CHRIST CHURCH BEXLEY

DEVELOPMENT APPLICATION DESIGN REPORT

COUNCIL RFI RESPONSES

08.03.2023

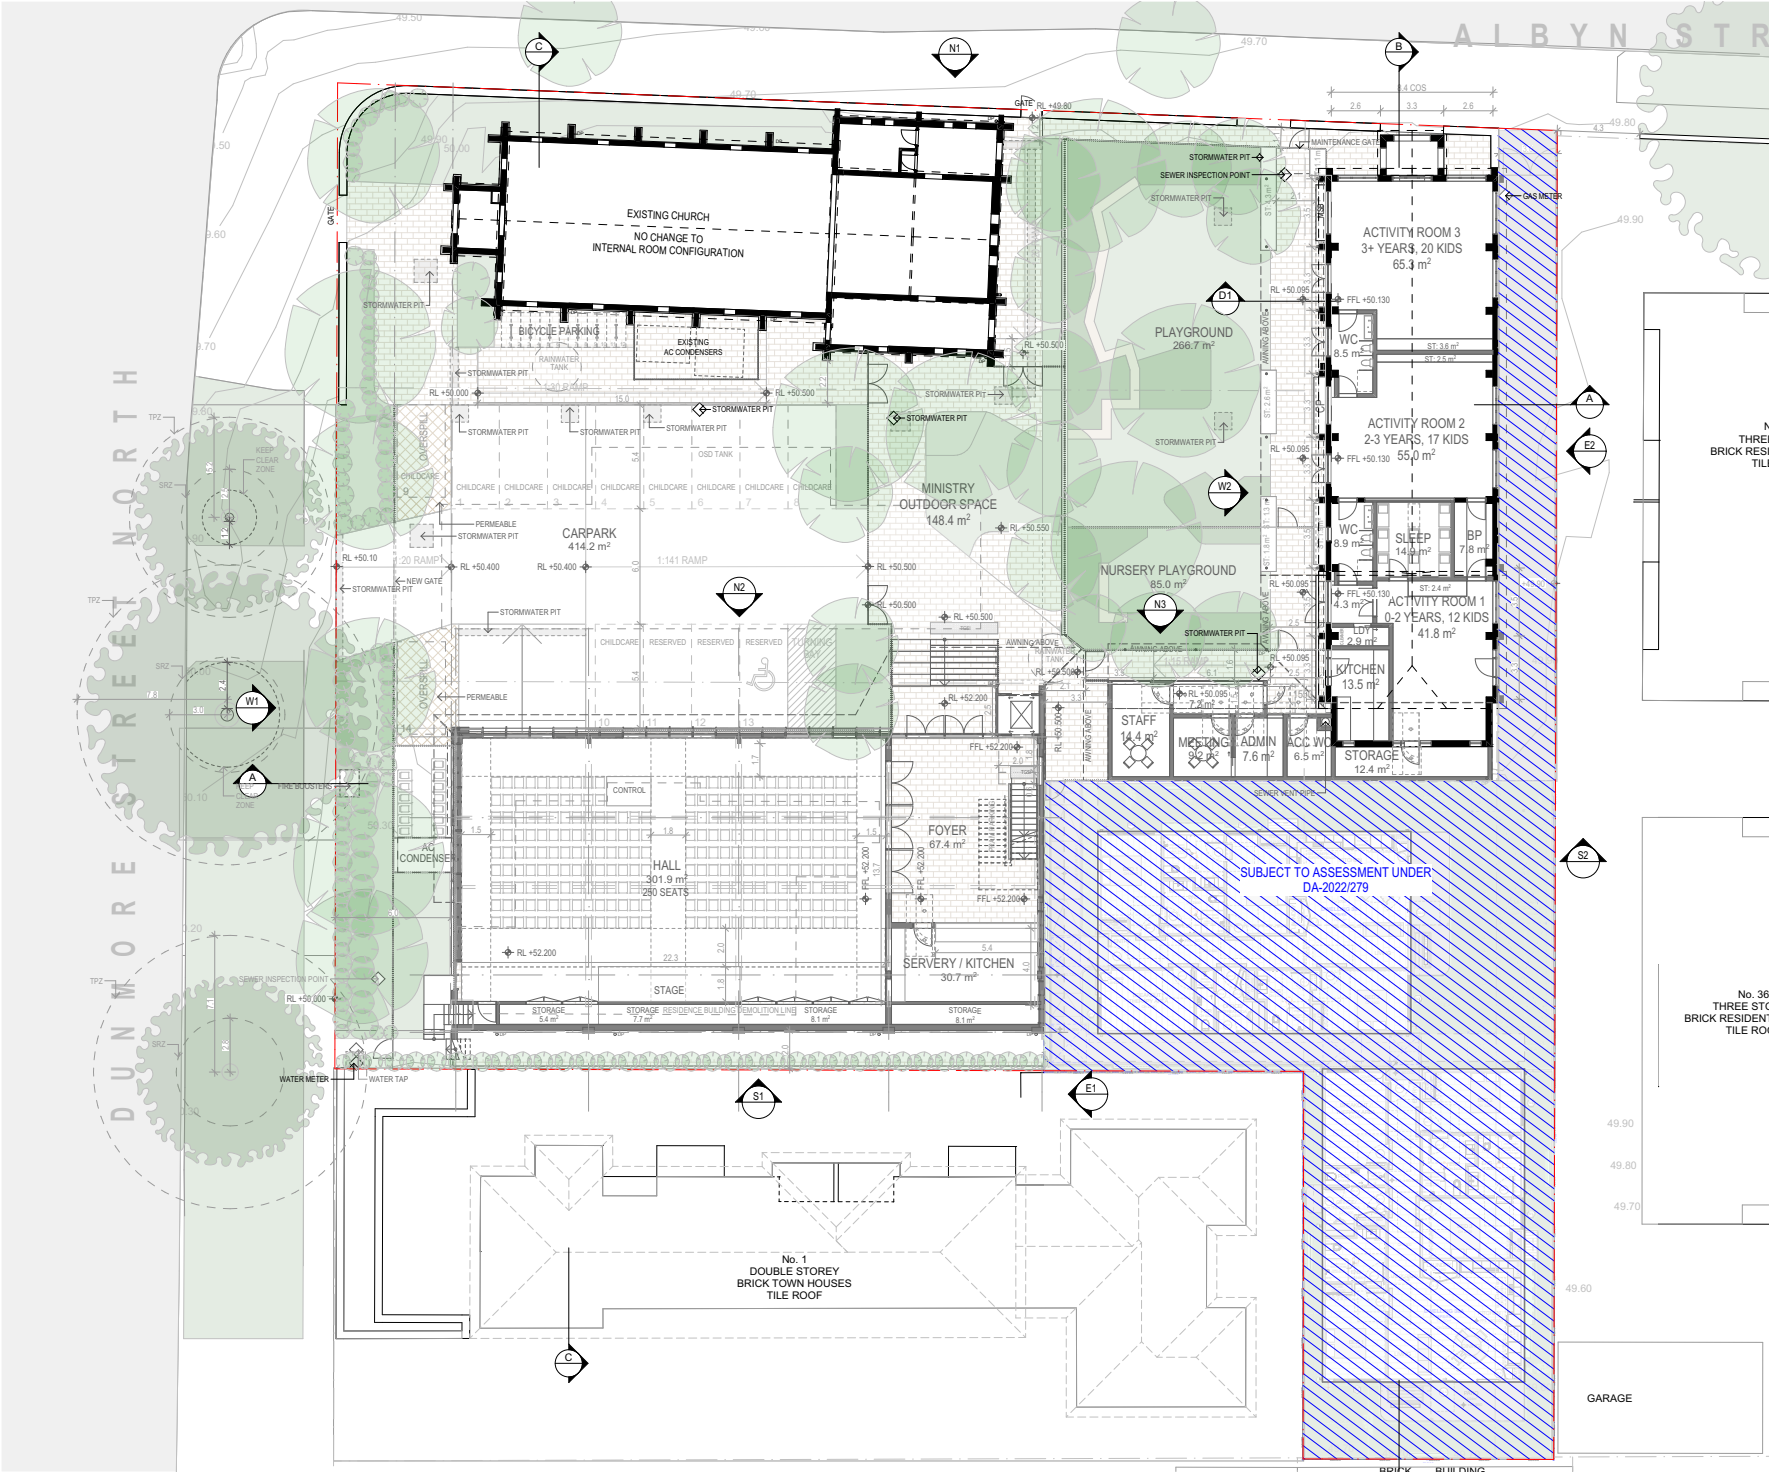
b Setbacks are reduced, and with poor landscape

Landscape setback of minimum 3 metres shall be provided along Dunmore Street North. These are not to include any structures, other than driveways and direct pedestrian access required, or existing heritage items. Therefore, the bin enclosure shall be relocated from front setback as it currently impacts on streetscape views. The present location diminishes the streetscape and provides a visual obstruction towards the heritage item. Instead, the setback shall include vegetation.

The southern landscape setback adjacent to 1 Dunmore Street North adjoining the two storey townhouses shall be increased to have a minimum setback of 2 metres. Further, this relates to the planting width along this interface is to be a minimum of 2 metres to allow buffer planting to provide privacy as well as landscaped setting for the townhouses.

All street frontages shall maximise the inclusion of tree planting.

The eastern setback has been designed to have direct access to the future SD dwellings which may include hard pavement to the majority of this area. This is not supported. The setback shall provide buffer planting towards the neighbouring property instead

c Structures and services within the landscape setback

Several structures proposed within the landscape setback shall be relocated, as these diminished the streetscape, amenity and also the deep soil and landscape area provided.

- Staircase along the setback shall be removed or reduced to address design amendments. This area should increase the amount of landscaping as it is the most visible part of the site from Dunmore Street North.
- No parking spaces of any kind shall be provided within the landscape setback.
- Fire booster shall be integrated within the building.
- The bin enclosure shall be relocated from front setback.

RESPONSE

Relocated bin enclosures, AC condensers and egress stairs outside 3m Dunmore St N site boundary setback
Fire booster unfortunately cannot move outside 3m setback according to AS2419.1, refer to relevant reports by ADP

View from neighbour ground floor - Proposed

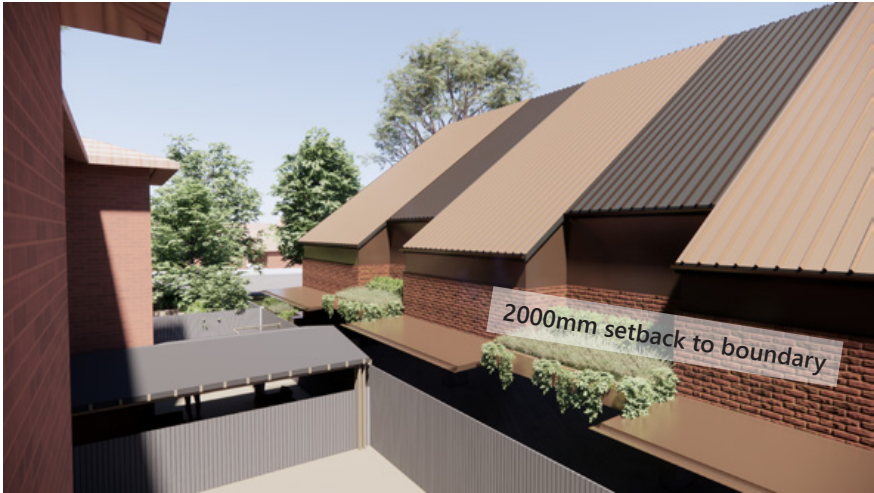
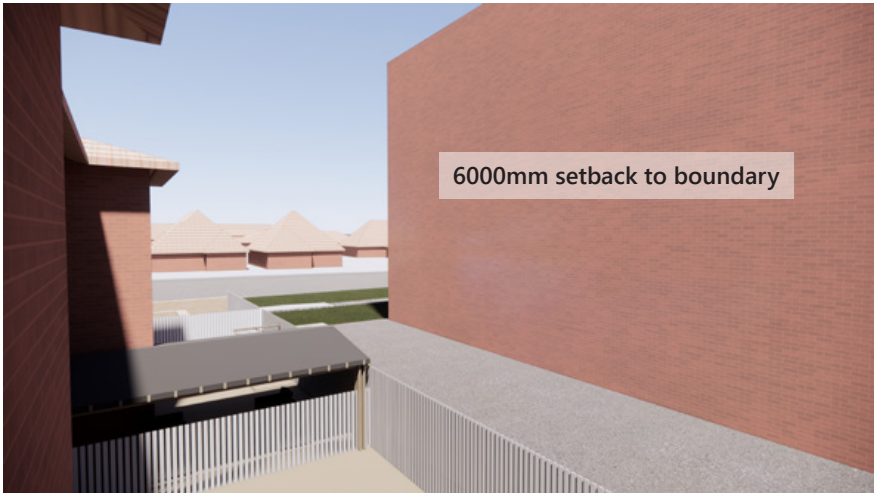
An additional photomontage is to be provided demonstrating the view of the proposal from the neighbouring property at 1 Dunmore Street North. Council is to determine the extent of roof that will be visible from this boundary at this elevation and whether the angle of the roof slope is acceptable. The analysis should be taken from the ground level courtyard and first floor of the neighbouring site.

Refer to additional images below demonstrating visual impacts

GFA PLAN - GROUND:

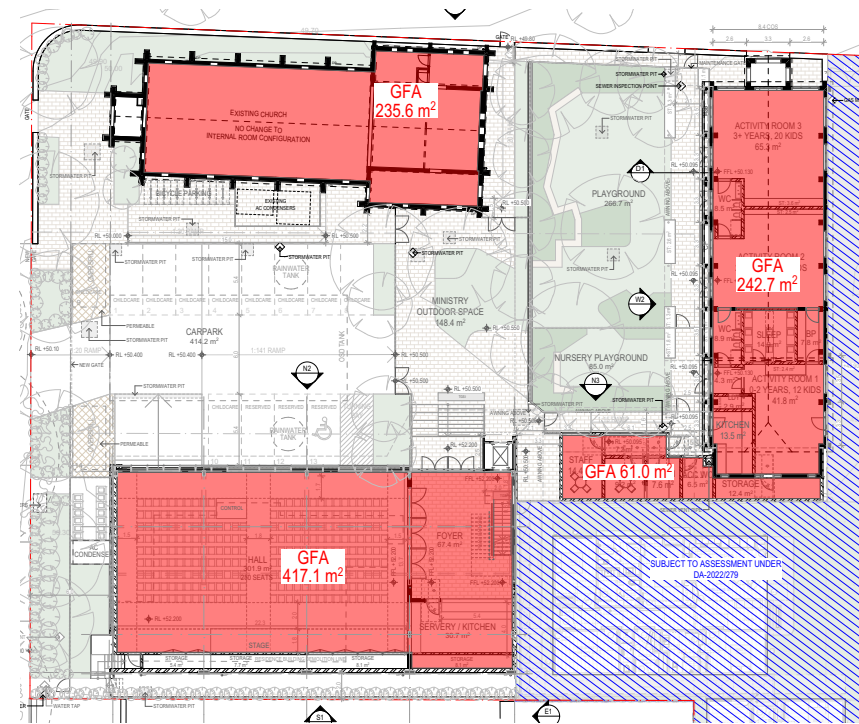
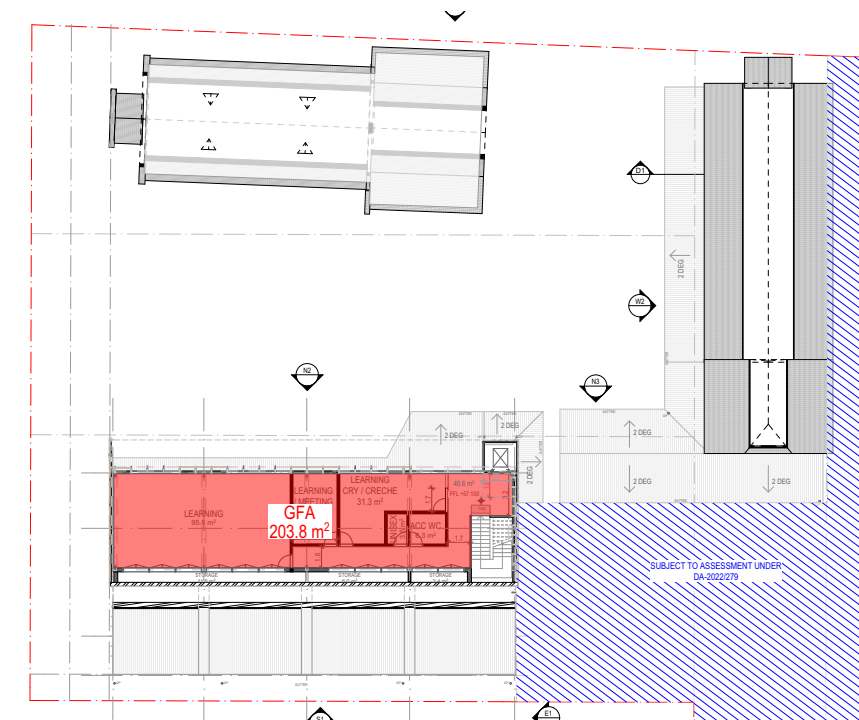
NO	COUNCIL COMMENTS
m	No FSR or landscape calculation plans are provided as part of the architectural package. This is to be provided.

RESPONSE

Landscape Calculation Plan; refer to 5a.
FSR calculation (GFA) plans refer to diagrams below.

View from footpath outside the SW corner of site (with proposed street trees)

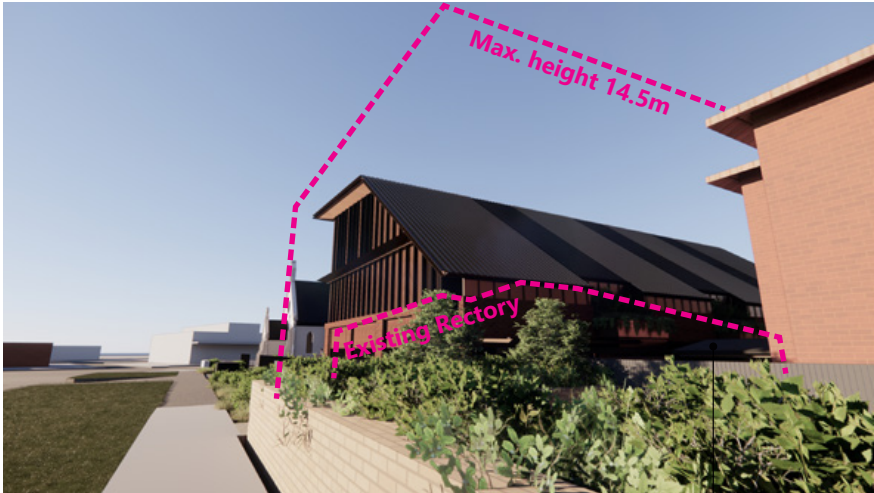
As per Council's comments: 'We also discussed in our meeting a visual impact analysis of the proposed church building as viewed from the neighbouring development (shown red on the aerial above). I didn't see that in the amended package.'

RESPONSE

To assist, please see additional view below.
